Reference: **WATERSTONE AT LEXINGTON** Date: May 8, 2019
55 Watertown Street
Log of Site Plan Updates

In addition to further developing design details primarily related to the final engineering of the stormwater systems in conjunction with the preparation of the Stormwater Management Report, Stantec has made various miscellaneous updates to the PSDUP drawings approved at the November 2018 Town Meeting. These updates are itemized below and where feasible depicted on the attached color-coded exhibits.

Exhibit A – Site Plan Updates

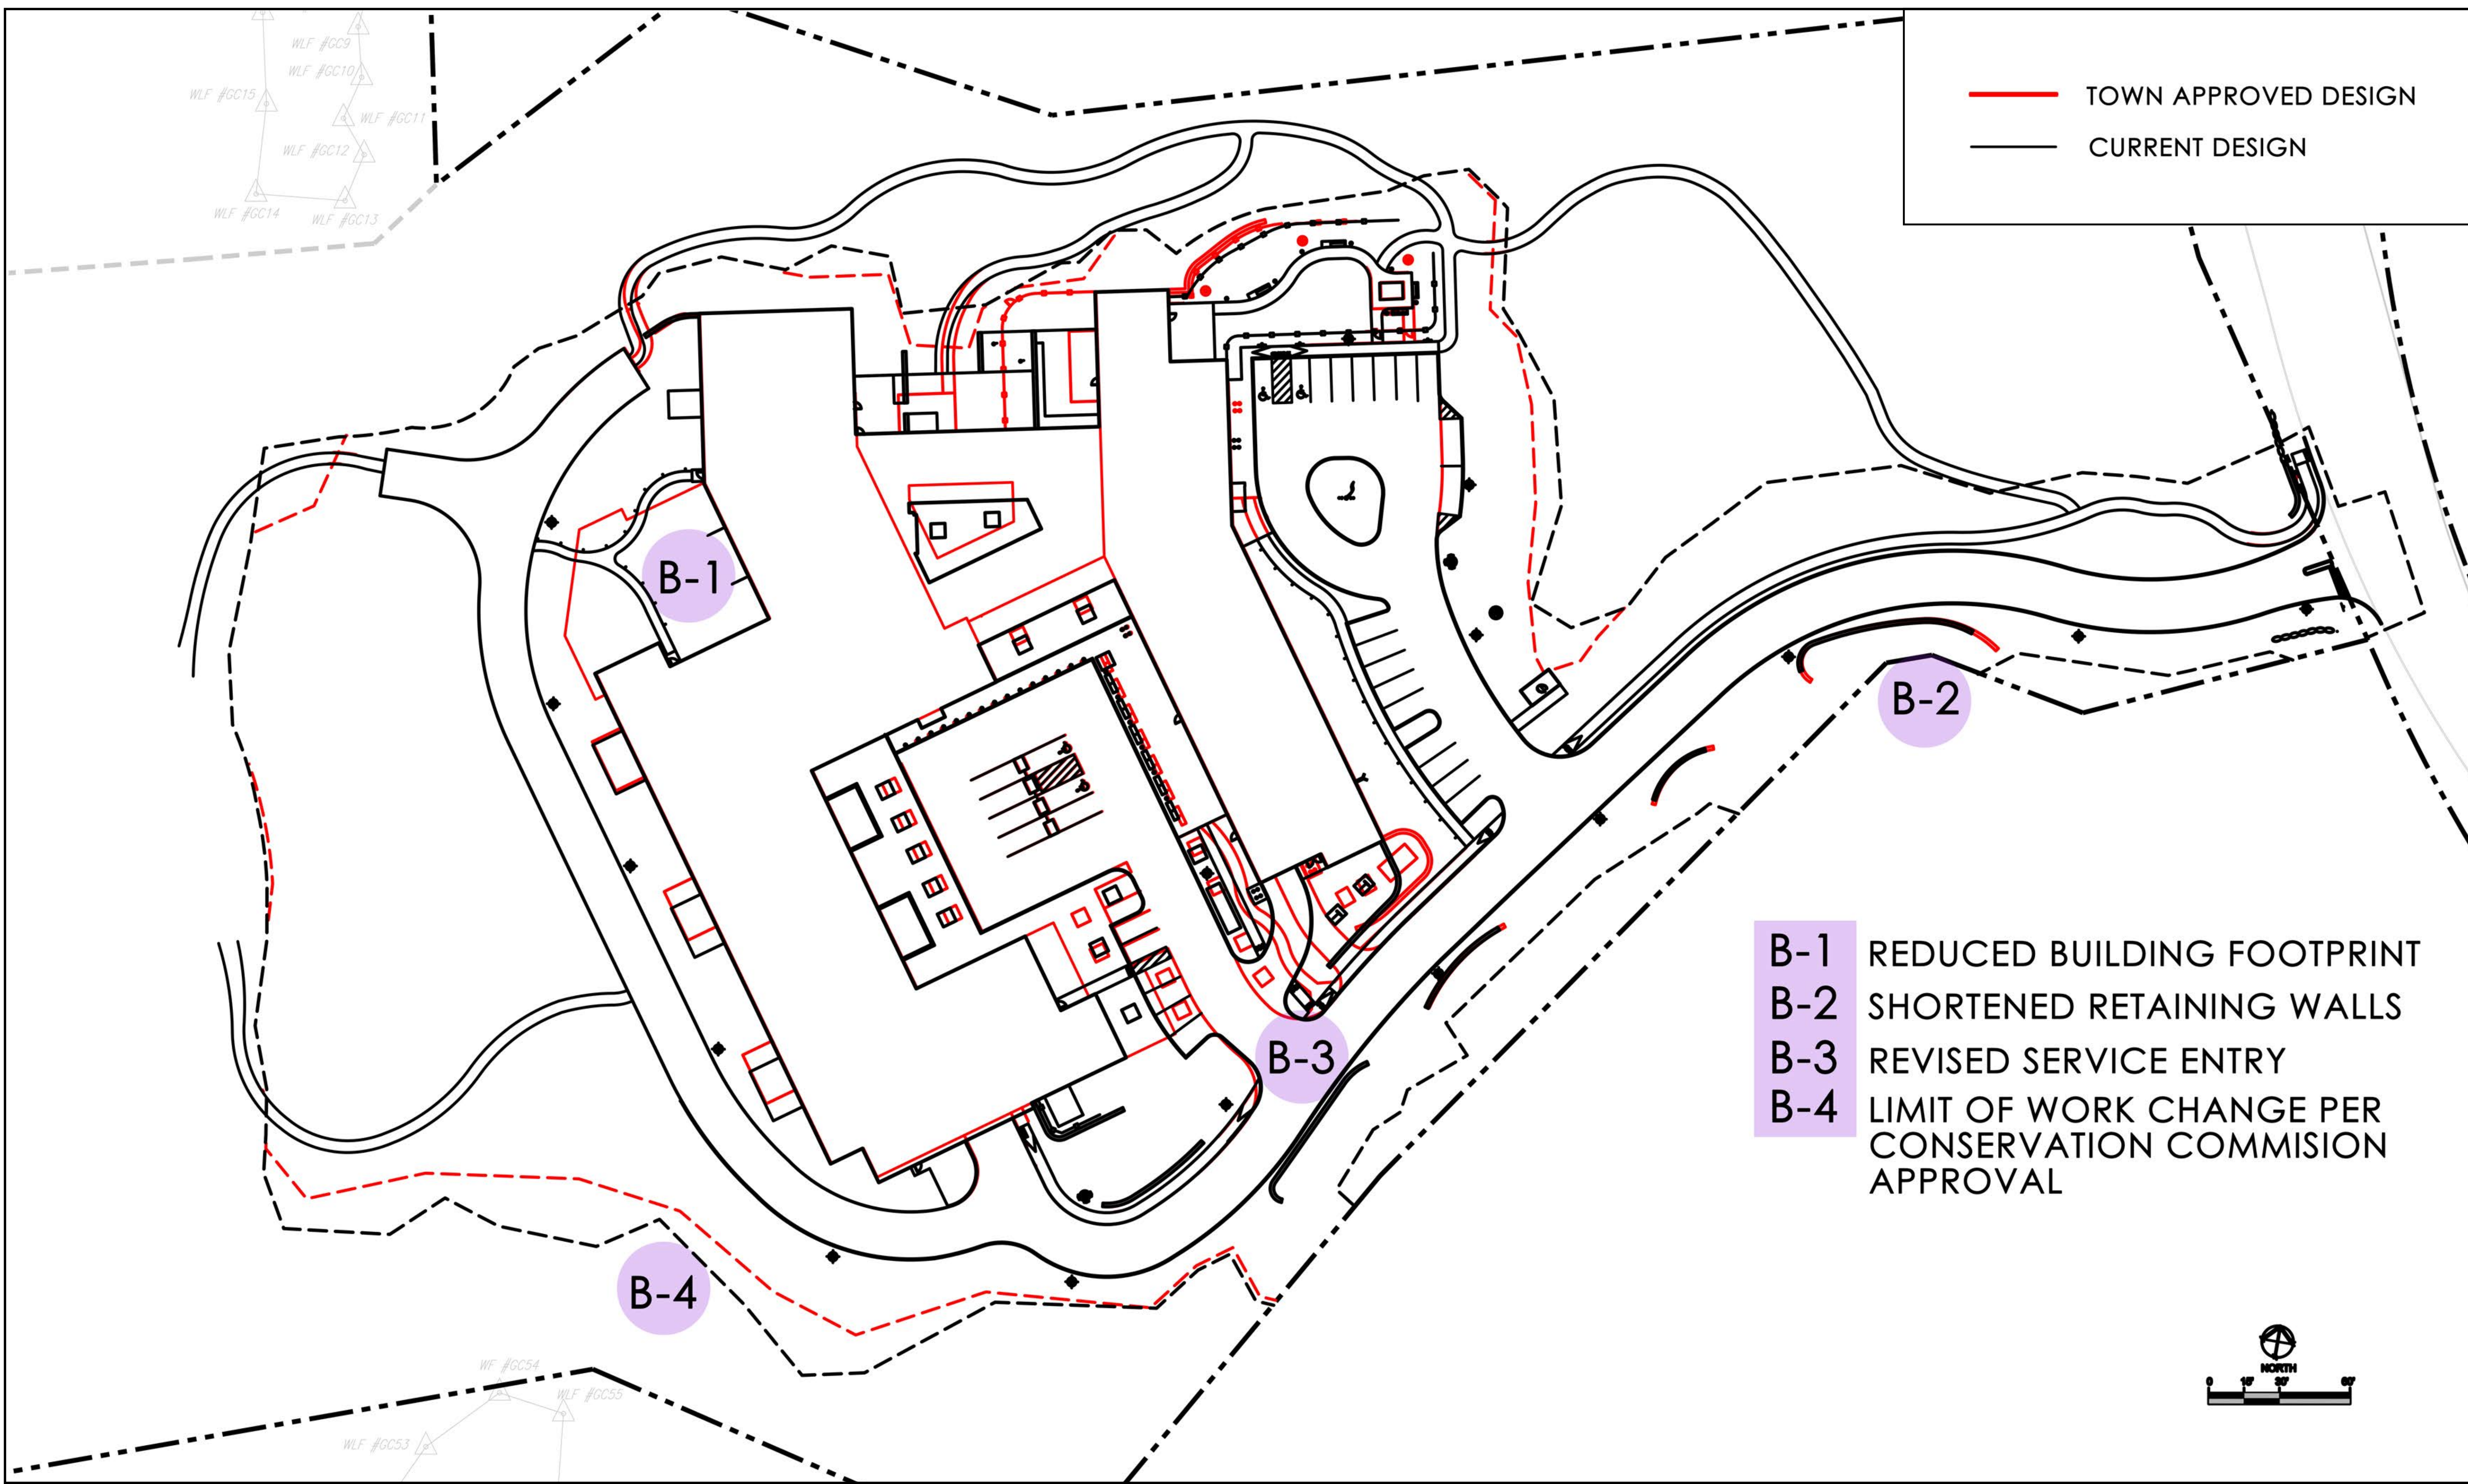
| <u>No.</u> | <u>Description of update</u> | <u>Plan(s) impacted</u> |
|-------------------|--|---|
| 2. | Added two parking spaces near walking trail at AL entrance as per the Memorandum of Agreement. Re-grade slope. <i>See Exhibit A, item #A-1 for general location.</i> | Layout and Materials Plan |
| 3. | Adjusted IL entrance drive to better accommodate service vehicles and resident traffic. <i>See Exhibit A, item #A-2 and item #A-7 for general location.</i> | Layout and Materials Plan |
| 4. | Added crushed stone around transformers at service entrance. <i>See Exhibit A, item #A-2 for general location.</i> | Layout and Materials Plan |
| 5. | Reorganized utility-entry/service area: shifted transformers per utility company standards, added catch basin, and added walk from service door on southern corner of building. <i>See Exhibit A, item #A-2 and Exhibit B.</i> | Layout and Materials Plan |
| 6. | Moved generator across entrance drive. <i>See Exhibit A, item #A-2 for general location.</i> | Layout and Materials Plan |
| 7. | Added small service apron concrete sidewalk area outside garage door. <i>See Exhibit A, item #A-3 for general location.</i> | Layout and Materials Plan |
| 8. | Refined IL and AL common area terrace/patio spaces. <i>See Exhibit A, item #A-6 for general location.</i> | Layout and Materials Plan |
| 11. | Added short sidewalk from egress door at IL courtyard. <i>See Exhibit A, item #A-2 for general location.</i> | Layout and Materials Plan |
| 12. | Added and graded path from egress at northwest corner of the building to fire lane. <i>See Exhibit A, item #A-7 for general location.</i> | Layout and Materials Plan, and Grading Plan |
| 13. | Revised grading of slope in southeast corner of site from 1:1 to 2:1 and removed riprap per Conservation Commission's RDA. This includes adjustments to limit of work approved by the Commission. <i>See Exhibit A, item #A-5 and Exhibit B, item #B-4 for general location.</i> | Grading Plan |

| 14. Regraded drive into IL entry area and parking court. <i>See Exhibit A, item #A-7 for general location.</i> | Grading Plan |
| 16. Added evergreens for screening transformers. <i>See Exhibit A, item #A-2 for general location.</i> | Planting Plan |
| 17. Added evergreens to screen generator. <i>See Exhibit A, item #A-2 for general location.</i> | Planting Plan |
| 18. Planted additional trees and shrubs in and near the buffer zone per Conservation Commission's RDA. <i>See Exhibit A, item #A-5 and Exhibit B, item #B4 for general location.</i> | Planting Plan |
| 21. Modified alignments of water and sewer lines based on updated transformer locations at service drive. <i>See Exhibit A, item #A-2 and Exhibit B, item #B-3 for general location.</i> | Utility Plan |
| 23. Slightly modified footprint of subsurface infiltration system. <i>See Exhibit A, item #A-3 for general location.</i> | Utility Plan |
| 25. Added riprap protection at basin inlet locations and at the basin emergency overflow. <i>See Exhibit A, item #A-4 for general location.</i> | Utility Plan |

Exhibit B – Site Plan Comparison

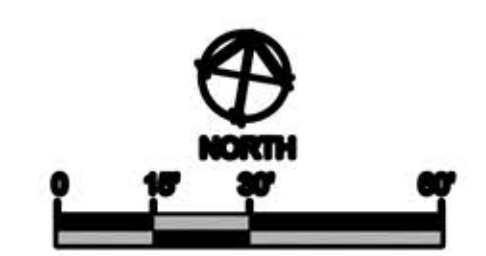
| <u>No.</u> | <u>Description of update</u> | <u>Plan(s) impacted</u> |
|-------------------|--|---|
| 9. | Slightly shortened walls along entrance drive. <i>See Exhibit B, item #B-2 for general location.</i> | Layout and Materials Plan |
| 10. | Reduced building footprint at northwest portion of the site. <i>See Exhibit B, item #B-1 for general location.</i> | Layout and Materials Plan |

— TOWN APPROVED DESIGN
 — CURRENT DESIGN

- B-1 REDUCED BUILDING FOOTPRINT
- B-2 SHORTENED RETAINING WALLS
- B-3 REVISED SERVICE ENTRY
- B-4 LIMIT OF WORK CHANGE PER CONSERVATION COMMISSION APPROVAL
